Planning and Development (Technical Plan Variation—Residential Zones Code) Notice 2008 (No 2)*

Notifiable instrument NI2008-542

Technical Amendment to the Territory Plan Code Variation V2008-10

Amendments to the Single Dwelling Housing Development Code and Multi-unit Housing Development Code

14) At Part C(1) – Single Dwelling Housing - substitute the existing figures titled 'Figure C1 Setbacks – Front Boundary less than 15m wide', 'Figure C2 Setbacks – Front Boundary more than 15m wide' and 'Figure C3 Setbacks – Corner Blocks' with the following figures (one per page):

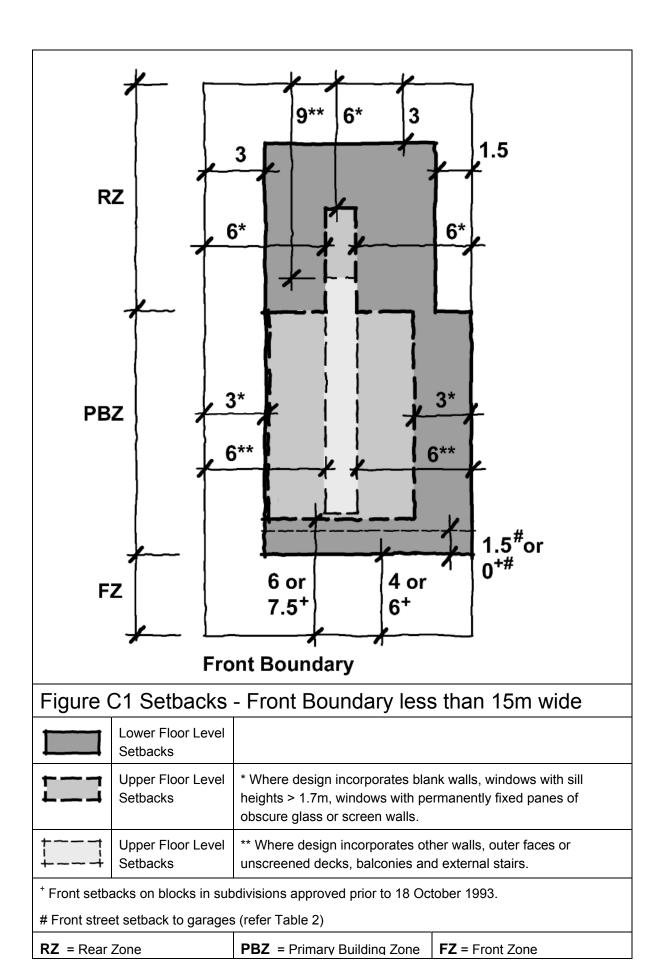
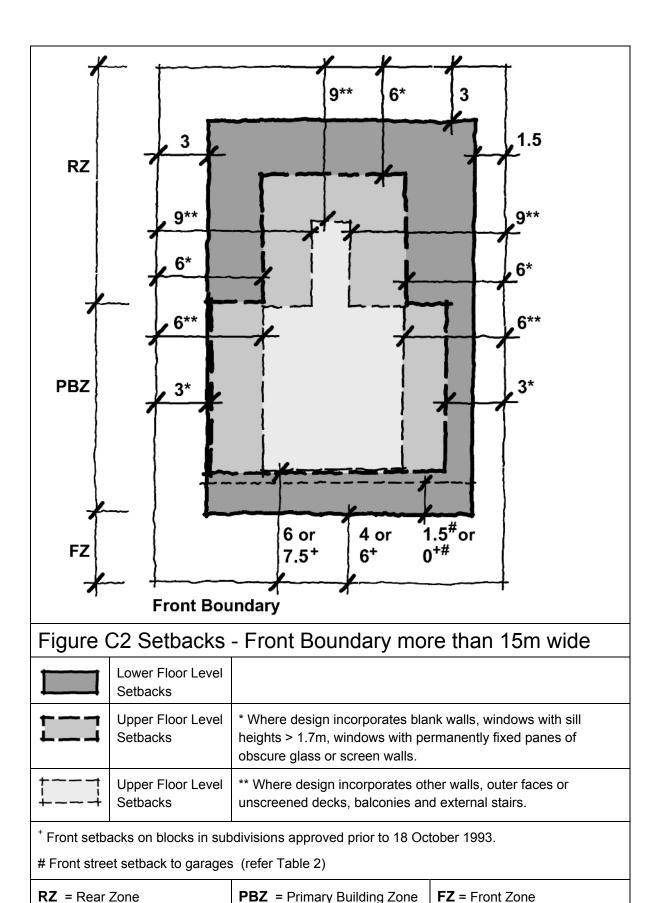
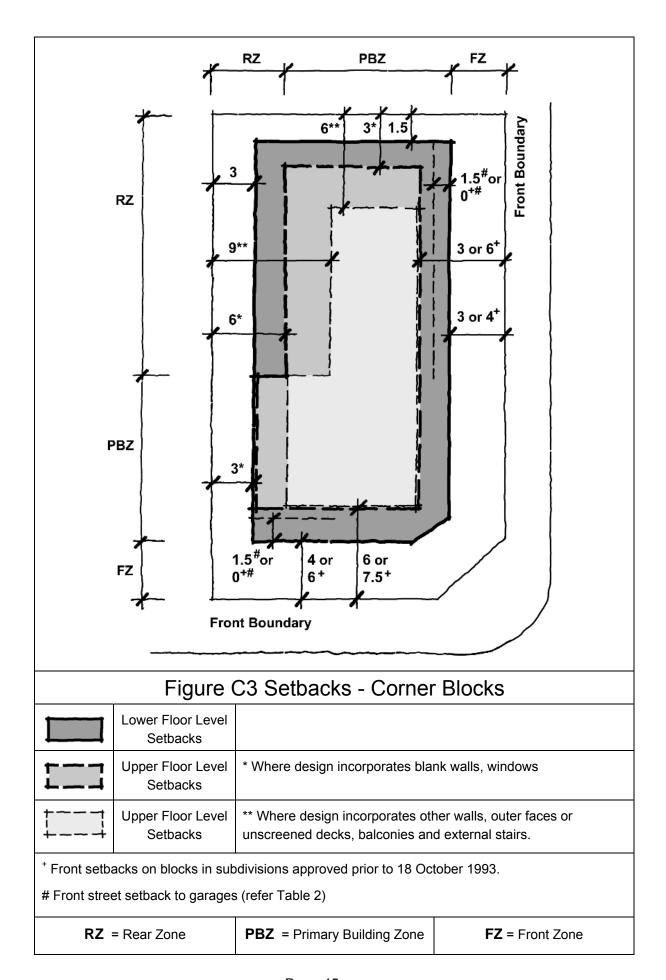
The proposed changes will clarify the requirements for setbacks to screened decks and bring it closer to what was included in the previous Territory Plan. Changes to Figures C1, C2 & C3 will also clarify what is meant by FZ, PBZ and RZ.

Figure C1A - Setbacks

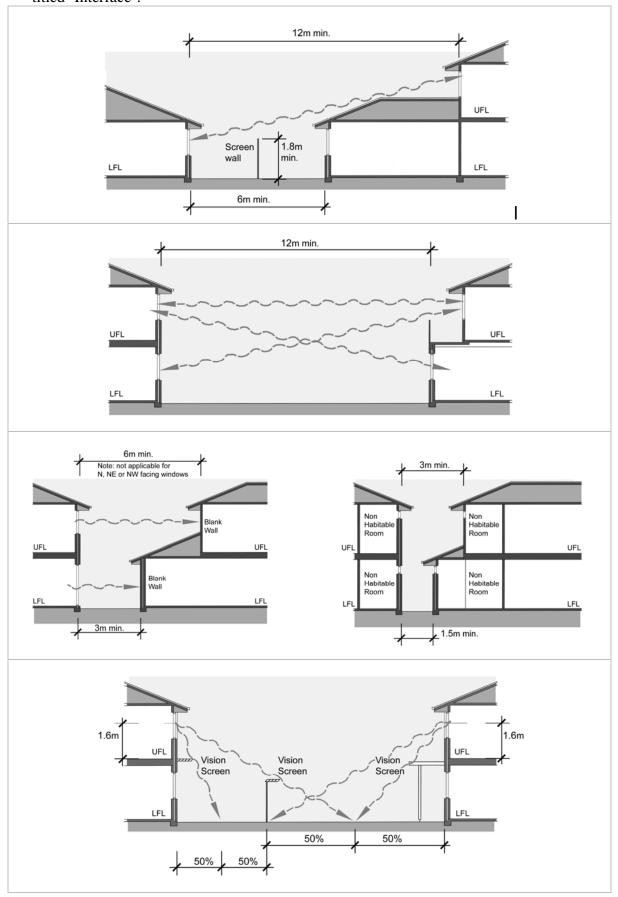
The proposed changes will clarify the requirements for the interface between walls and bring it closer to what was included in the previous Territory Plan. The diagrams from the previous Territory Plan will also be added to illustrate these requirements. A reference to the new diagram will also be added to R69

31) At Part C(1) – Multi Unit Housing – insert the following diagram under section 3.3 titled 'Interface':

The minimum interfacing distance (refer figure C1A):

- a) of balconies, unscreened decks or windows (other than fixed obscure glazing) or glazed doors to a habitable room in a dwelling from the external wall of any other dwelling on the subject site is:
 - (i) 6 m if both dwellings at lower floor level and a screen wall provided
 - (ii) 12 m otherwise
 - (iii) or where the external wall of the other dwelling is a blank wall and is not located to the north, north-east or northwest of the first dwelling, the minimum distance is:
 - 3 m if external wall at lower floor level
 - ii. 6 m if external wall at upper floor
- b) of windows to other than habitable rooms and fixed obscure glazing from the external wall of any dwelling on the subject site is:
 - (i) 1.5 m if both dwellings at lower floor level
 - (ii) 3 m otherwise
- between blank walls of dwellings on the subject site where a party wall is not provided is 1 m.

Outlook from windows, balconies, stairs, landings and decks or other private, communal or public areas within a development are designed, screened or obscured to prevent overlooking of more than 50% of the private open space of another dwelling on the same block (refer figure C1A)
